**STATE OF HAWAII
DEPARTMENT OF TRANSPORTATION
(HDOT) HIGHWAYS**

**ADDENDUM NO. 2
FOR
HDOT PUNCHBOWL OFFICE RENOVATION
DISTRICT OF HONOLULU
ISLAND OF OAHU
PROJECT NO. HWY-02-27M**

September 28, 2026

ENLARGED FLOOR PLAN – RENOVATION (PARTIAL 5TH FLOOR)
A003/A003 Scale: 1/4" = 1'-0"

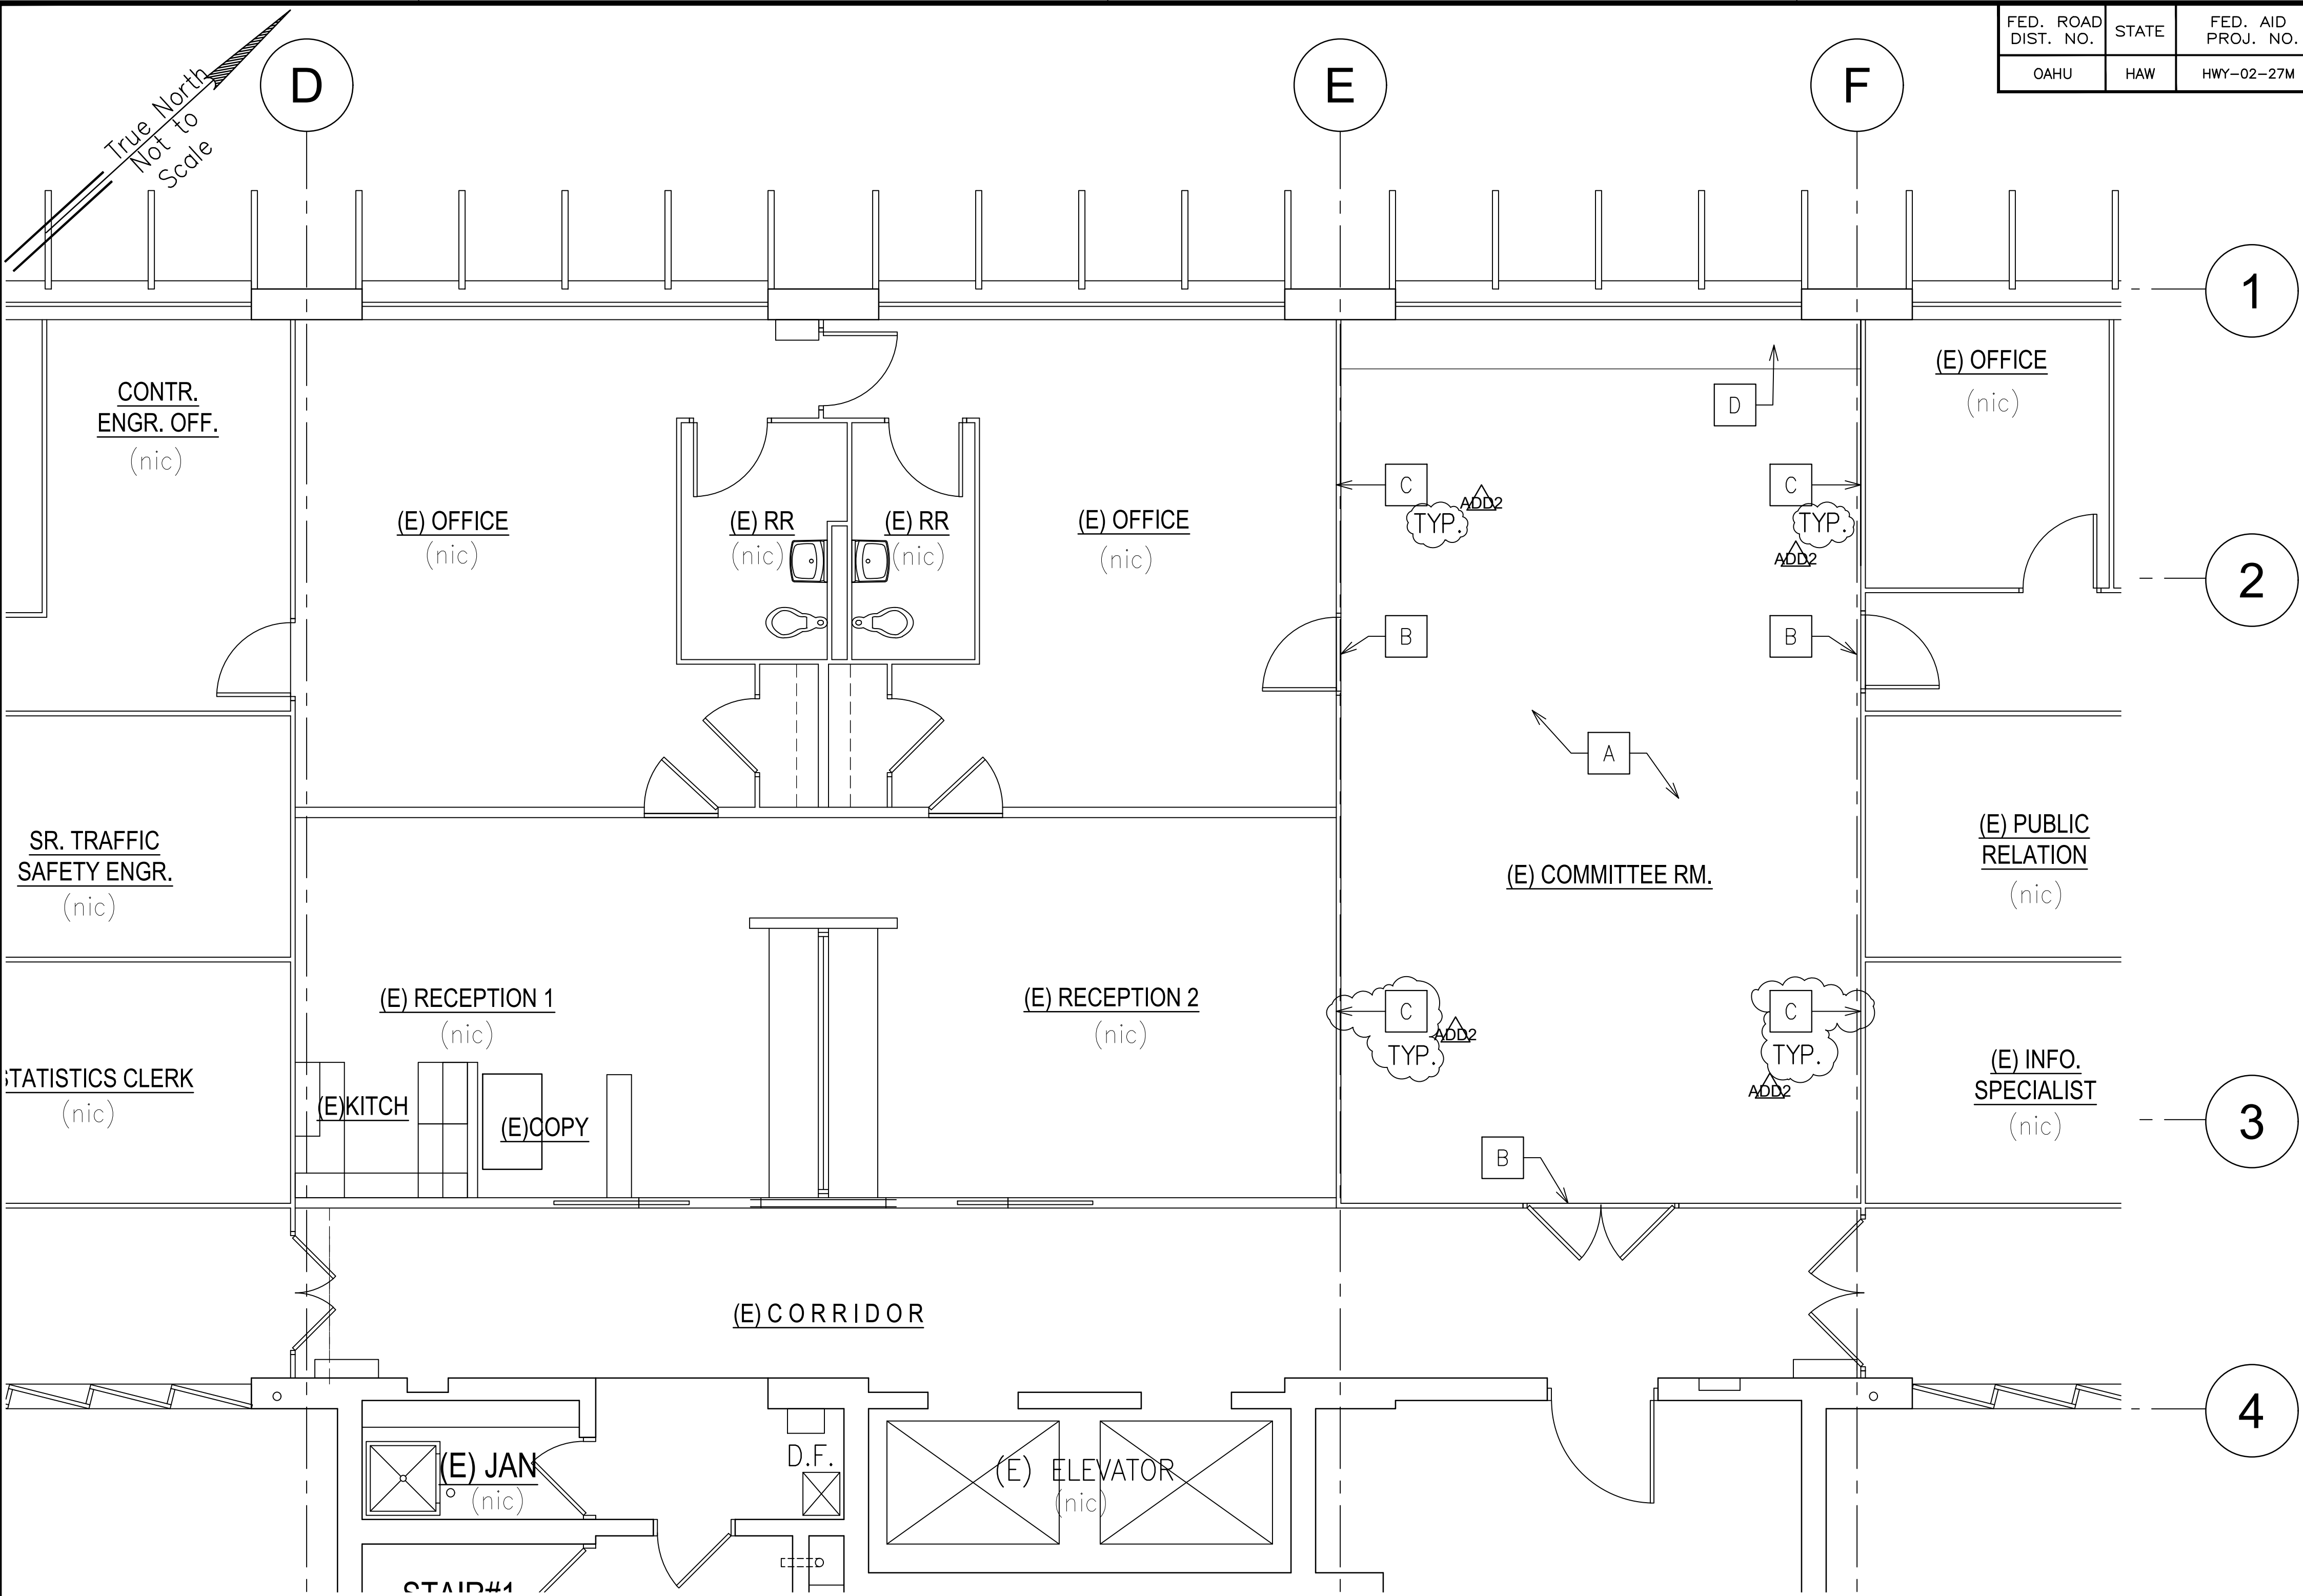
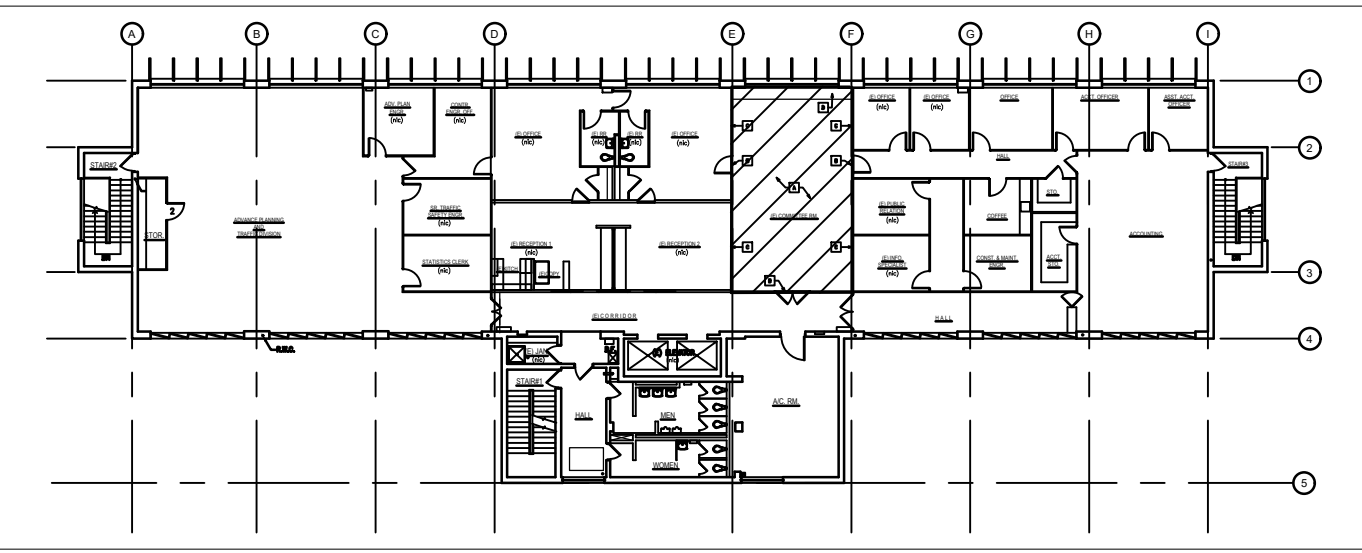
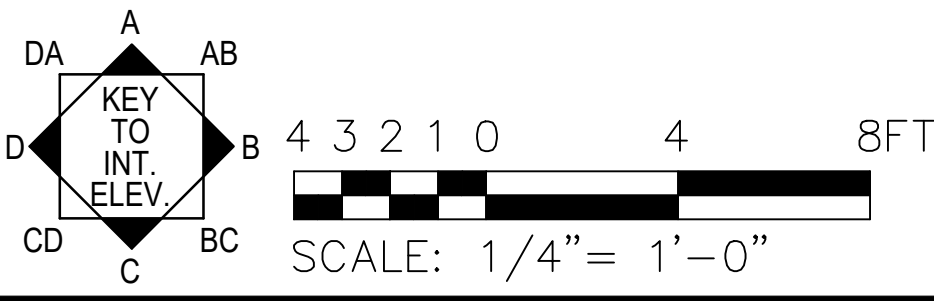
22. Sheet A003 shows three new door thresholds and refers to the specifications, but no threshold specification or detail was found. Please provide the required material, profile, dimensions, finish, and anchorage for the new thresholds.

24. Sheet A003 identifies Reception 2 as N.I.C.; however, Sheet M200 shows a supply slot diffuser and associated ductwork within Reception 2. Please confirm whether this mechanical work is included in the contract.

**NO. ADD. 2, A006 - INTERIOR ELEVATION – RENOVATION FINISH
SCHEDULE** dated 9/28/2026.

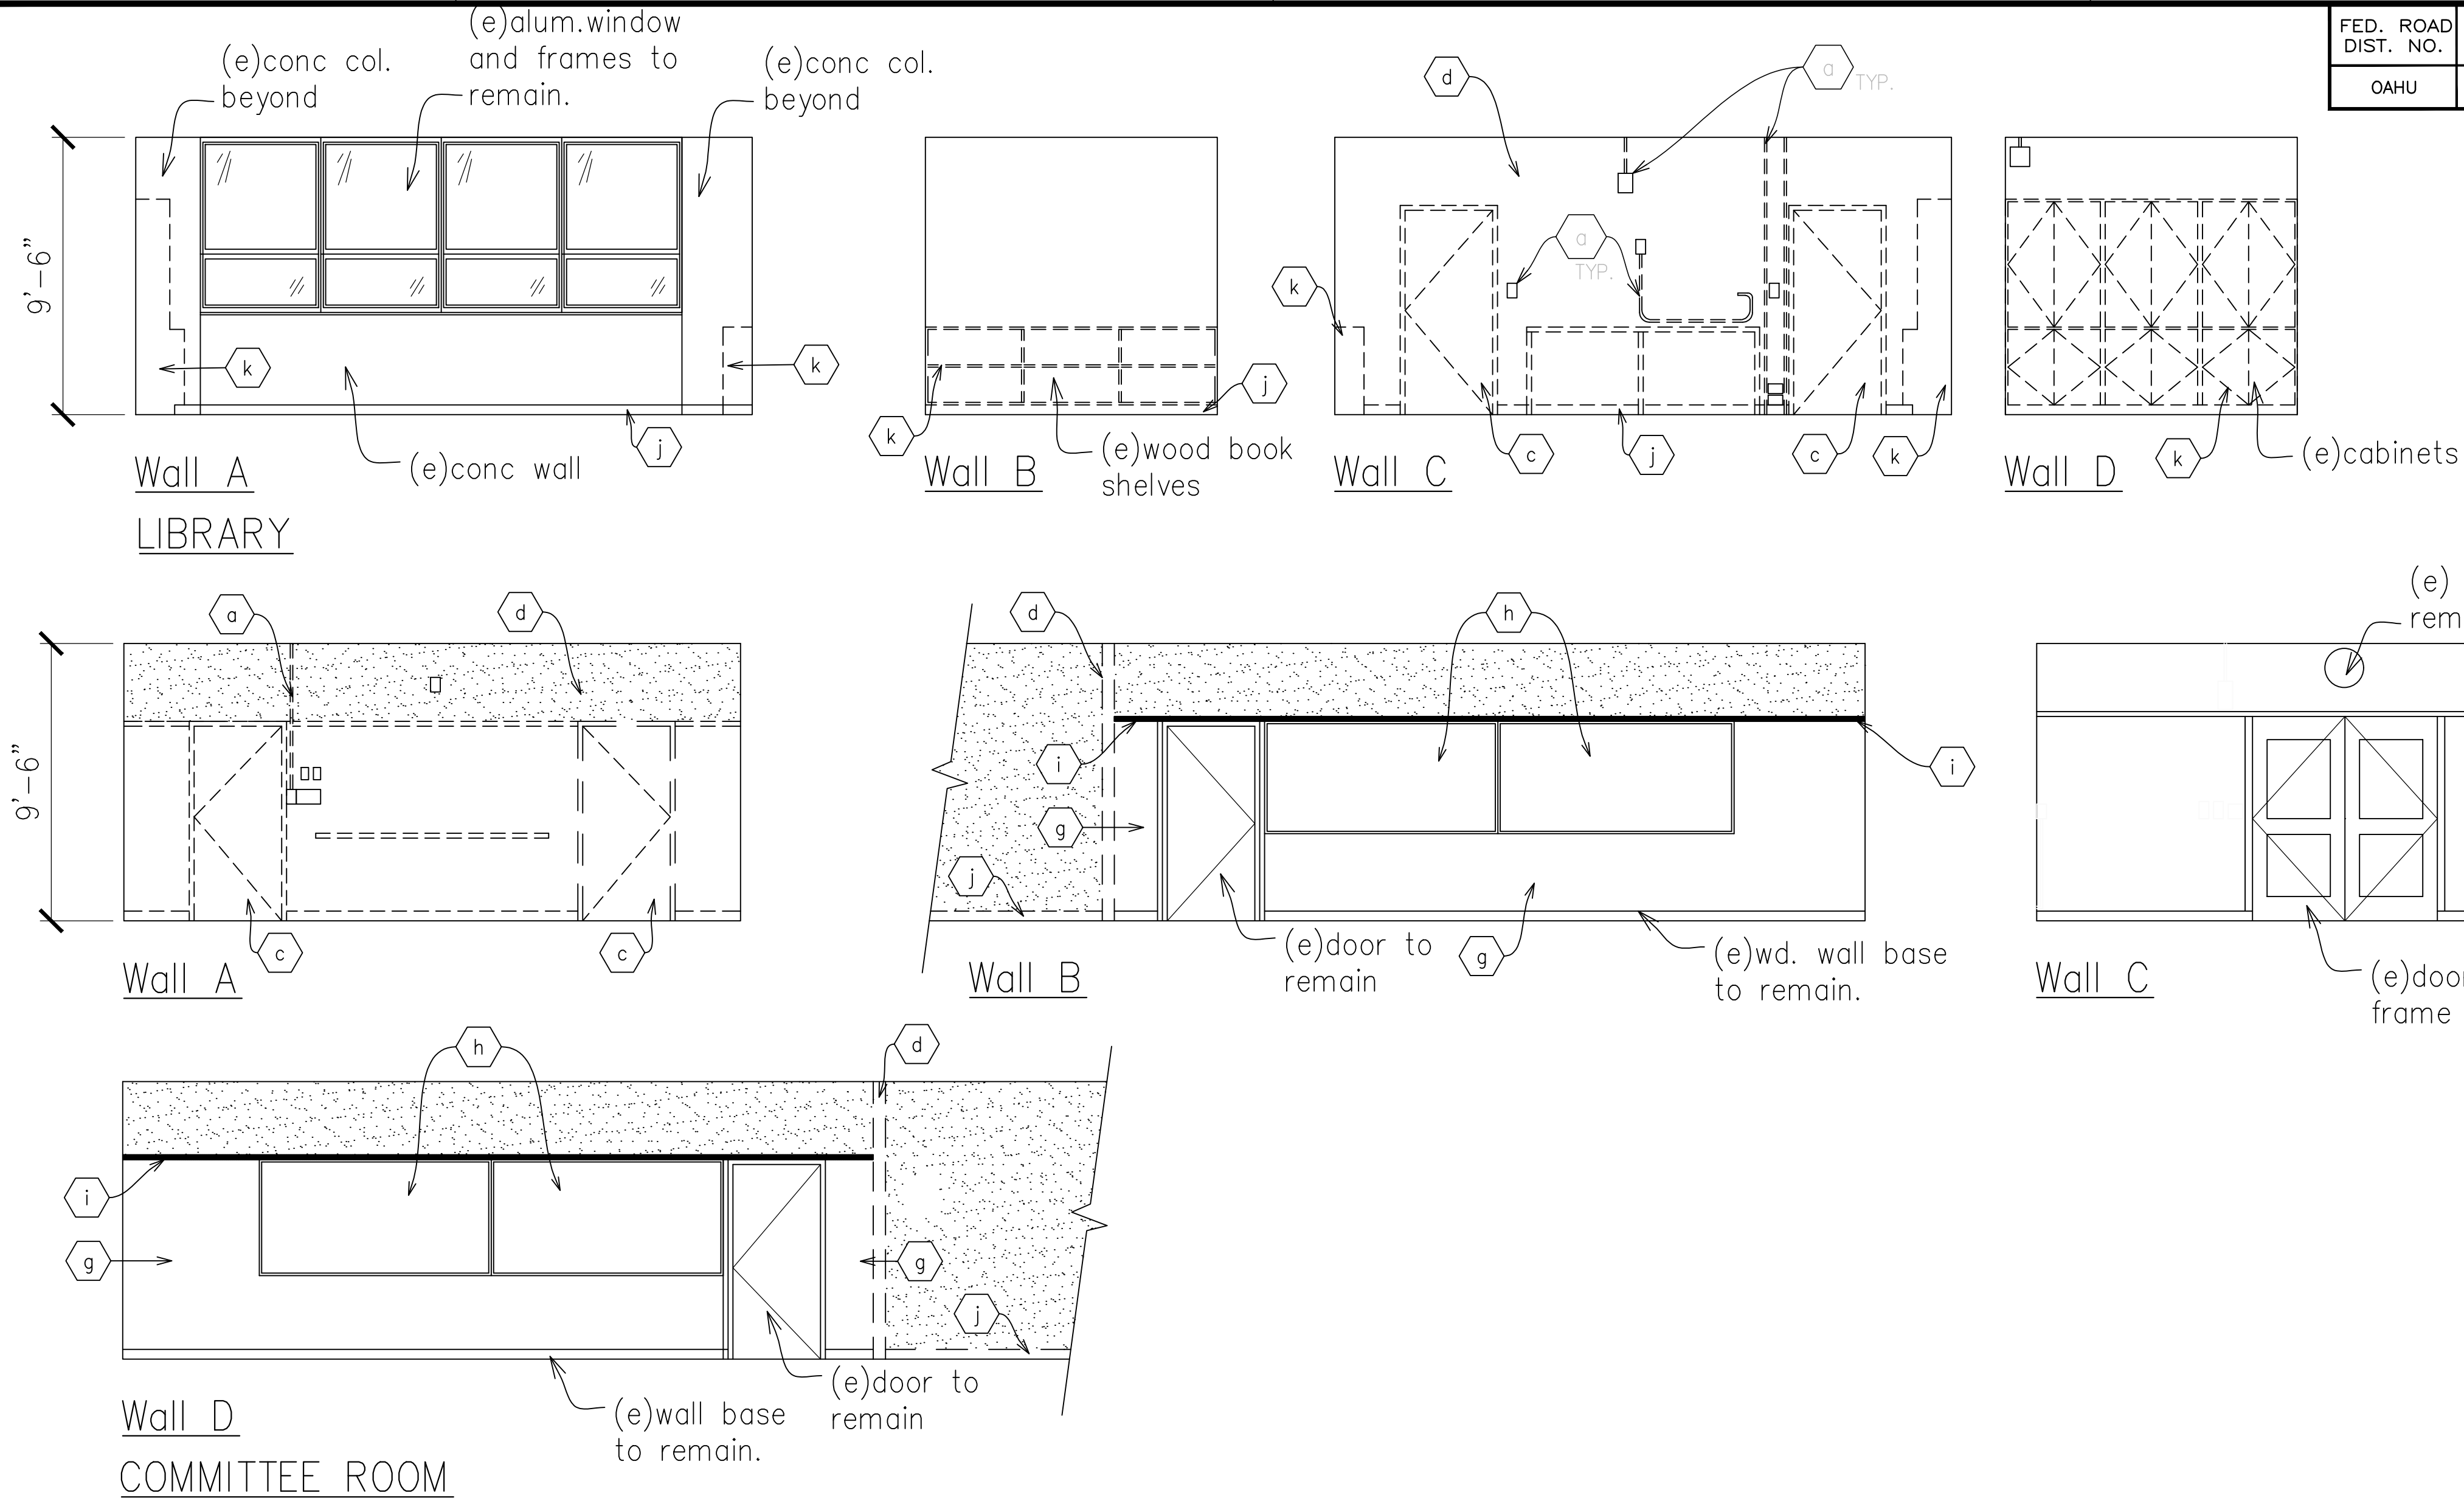
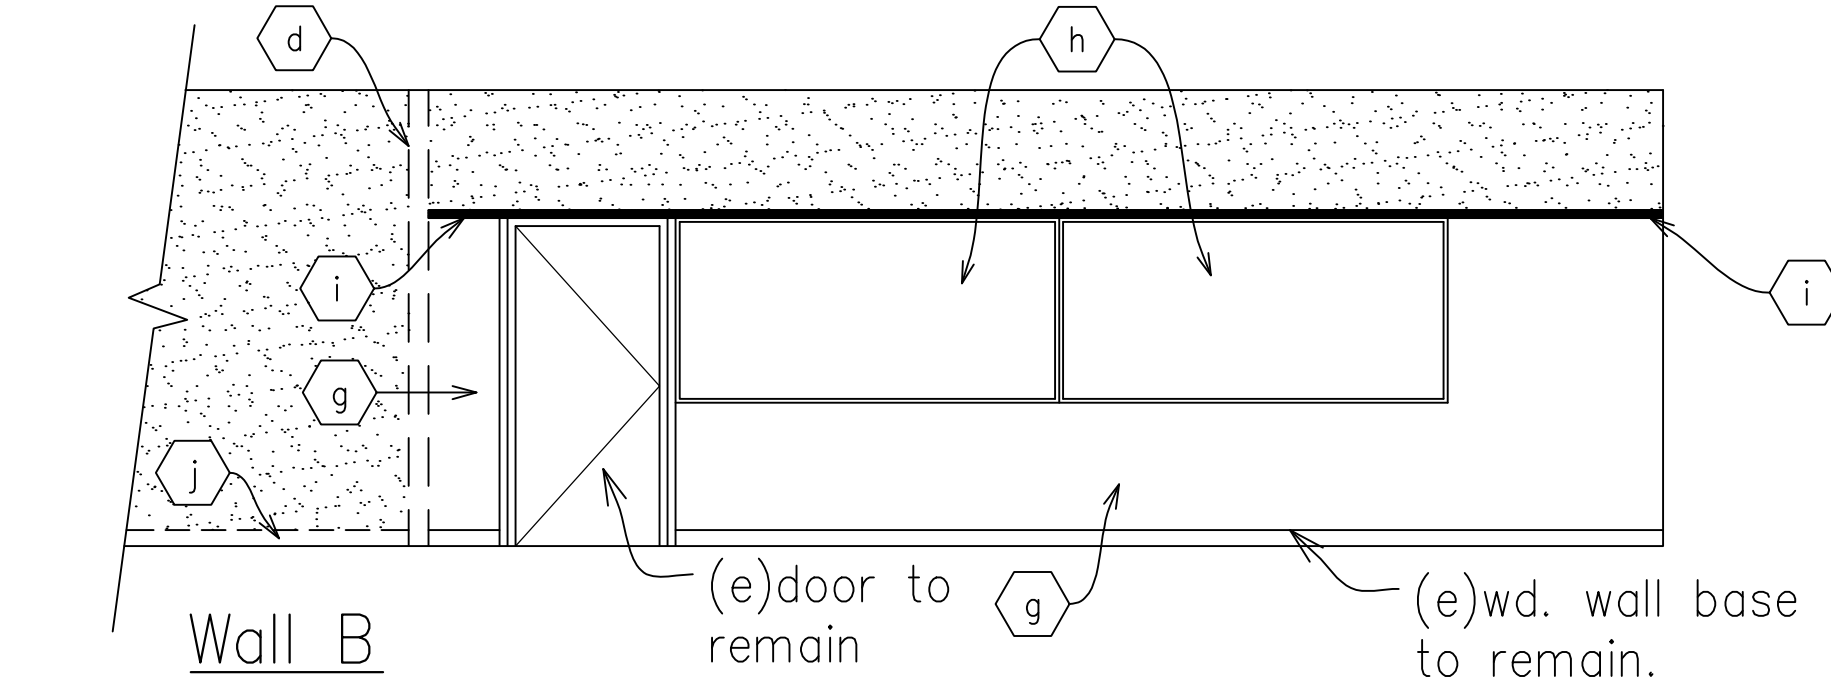
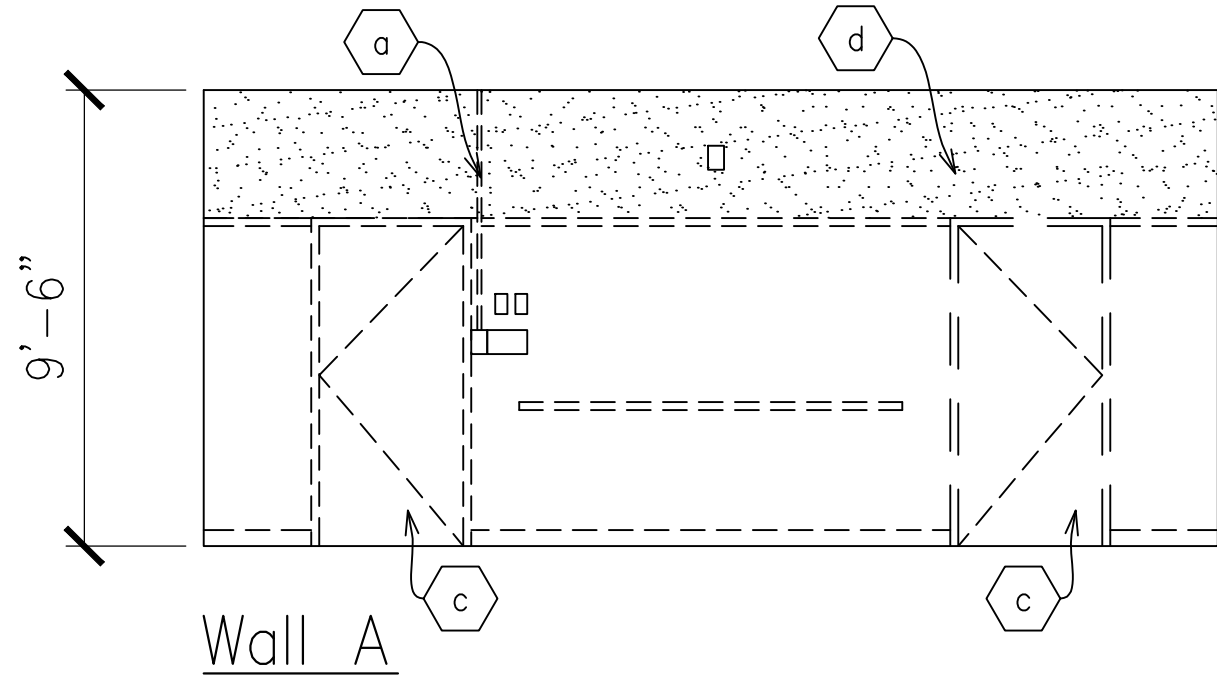
12. Provide the required configuration, glass type, framing, finish, door hardware and dimensions for the new entry glass doors and window walls referenced in the Notice to Bidders and Sheet A006.

25. Sheet A006 lists RB-1, 4-inch Burke Type TS rubber base in Sterling Gray “throughout,” while the elevations and notes show existing wood base to remain and new wood trim base to match adjacent. Please identify the exact limits of the rubber base and the existing or new wood base.

Revised Addendum No. 2, **Sheet A006 – INT ELEV RENOVATION, FIN SCH**, omitting notation “A” from “Renovation Key Note” for clarification. Glass partition wall and door system is not a part of this scope of work.

Response: See **Addendum 2, Sheet A006 – INT ELEV, FIN SCH.** “RB-1 Rubber Base” should be used at cabinets. All other spaces, existing wood base is to be reused. Where new wall base is needed, wall base shall match adjacent wood base.

Response: See **Addendum 2, Sheet A006 – INT ELEV, FIN SCH.** “RB-1 Rubber Base” to be used at cabinets. Existing wood base is to be reused. Where new wall base is needed, wall base shall match adjacent wood base.
